UNITED STATES PATENT AND TRADEMARK OFFICE

| APPLICATION NO. | FILING DATE | FIRST NAMED INVENTOR | ATTORNEY DOCKET NO. | CONFIRMATION NO. |
|-----------------|-------------|----------------------|---------------------|------------------|
| 09/750,073 | 12/29/2000 | Joun Ho Lee | 8733.376.00 | 6225 |

Office Action Summary

DETAILED ACTION

Fig. 3

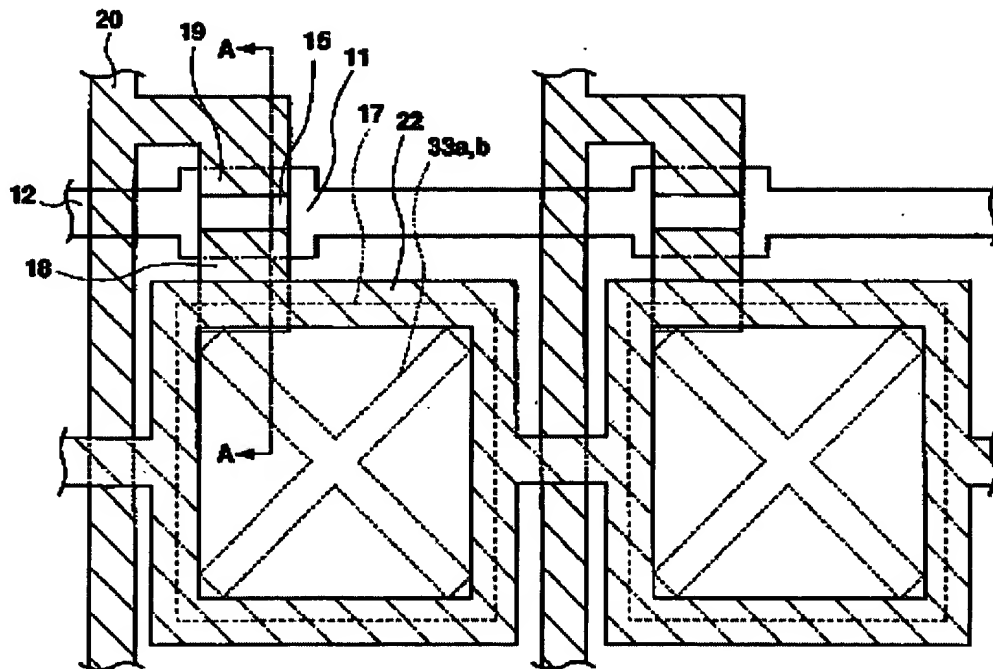
As to claims 1 and 10, Koma discloses in Figures 3-7, (First embodiment, col. 5, line 21 through col. 7, line 67) a multi-domain liquid crystal display device comprising: a first substrate, 10, defined by a plurality of pixel regions; an orientation control electrode, 22, (Applicant's common auxiliary electrode) (col. 6, lines 5-8) around each pixel region on the first substrate; an orientation control window, 33a, filled with orientation film material, 34, (Applicant's dielectric structure) (col. 6, lines 28-34) (running from lower left to upper right) on a second substrate, 30, the dielectric structure being divided each pixel region into a plurality of domains (lower right domain from upper left domain); an additional structure (portion of 34 in 33a running from upper left to lower right) compensating electric field around a corner portion within each pixel region; and a liquid crystal director, 40, (Applicant's liquid crystal layer) between the first substrate and the second substrate.

As to claim 2, Koma discloses in Figures 3-7, (First embodiment, col. 5, line 21 through col. 7, line 67) the multi-domain liquid crystal display device of claim 1, further comprising: a plurality of gate lines, 12, on the first substrate in a first direction; a plurality of drain lines, 20, (Applicant's data lines) formed in a second direction to cross the first direction; thin film transistors (col. 5, lines 27-31) formed in a portion where the gate lines cross the data lines; and a display electrode, 17, (Applicant's pixel electrode) connected with the thin film transistors in the pixel region defined by the gate lines and the data lines.

As to claim 5, Koma discloses in Figures 3-7, (First embodiment, col. 5, line 21 through col. 7, line 67) the multi-domain liquid crystal display device of claim 1, wherein the orientation control electrode, 22, (Applicant's common auxiliary electrode) is not formed with the gate electrode, 11, (Applicant's gate lines) (on different layers per Figure 4, see also col. 5, lines 42-46).

As to claim 14, Koma discloses in Figures 3-7, (First embodiment, col. 5, line 21 through col. 7, line 67) a multi-domain liquid crystal display device comprising: first and second substrates, 10 and 30; a plurality of gate lines, 12, and drain lines, 20, (Applicant's data lines) on the first substrate to cross each other; orientation control electrodes (Applicant's common auxiliary electrodes) within and around each pixel region (per Figure 3) on the first substrate; an orientation control window, 33a, filled with orientation film material, 34, (Applicant's dielectric structure) (col. 6, lines 28-34) (running from lower left to upper right), and an additional structure (portion of 34 in 33a running from upper left to lower right) (Applicant's plurality of dielectric structures) on the second substrate, 30, corresponding to a region where the common auxiliary electrodes are not formed (per Figure 3); and a liquid crystal director, 40, (Applicant's liquid crystal layer) between the first substrate and the second substrate.

formed in a portion where the gate lines cross the data lines; a plurality of pixel regions between neighboring gate and data lines; an orientation control electrode (Applicant's common auxiliary electrode) around and within each pixel region (per Figure 3); a plurality of display electrodes, 17, (Applicant's pixel electrodes) formed in each pixel region to connect with the thin film transistors; an orientation control window, 33a, filled with orientation film material, 34, (Applicant's dielectric structure) (col. 6, lines 28-34) (running from lower left to upper right), and an additional structure (portion of 34 in 33a running from upper left to lower right) (Applicant's plurality of dielectric structures) on the second substrate in a region where the common auxiliary electrode is not formed (per Figure 3); an orientation film, 23 and 34, (Applicant's alignment film) on the first substrate and the second substrate, respectively; and a liquid crystal director, 40, (Applicant's liquid crystal layer) between the first substrate and the second substrate.
